SKEP III Home Office Support Site Visit Report

Consultant	Wahib Medanat Consultant Engineer	Rep No.	13-20032022
Contractor	Derar Saraireh & Sons for Engineering & Contracting	Tender No.	(11/2019/USAID/SKEP/3/S) Schools for a Knowledge Economy Project (SKEP) - Phase (3) Package (1, 2)
Site Name	Khadija Bint Khwailed Basic Mixed School- Shouna Janoubia	Day/ Date	Sun. 20/03/2022
Duration of Project	450 Calendar Days	Total Project Budget	9,789,417.840 JD

Visit Notes

(Figure: 04)

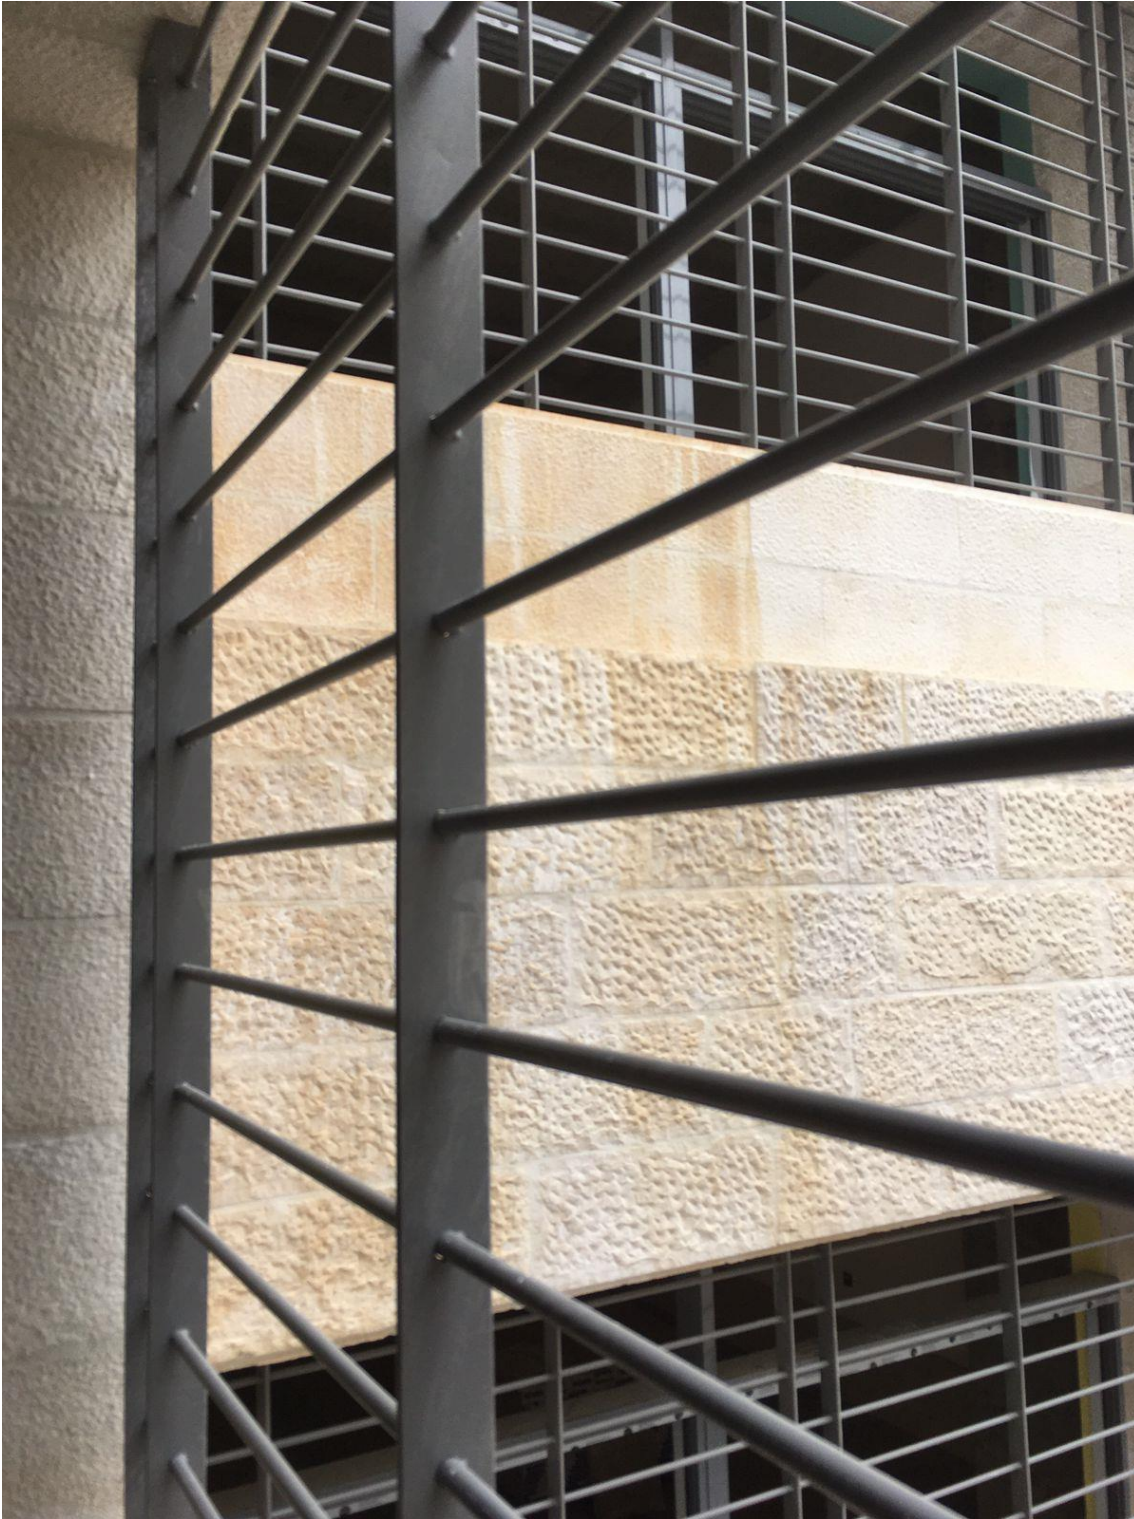
The supervision team inspected the external plastering-final finish executed for some parts of boundary walls. The Contractor was requested to remove and comply with the approved sample
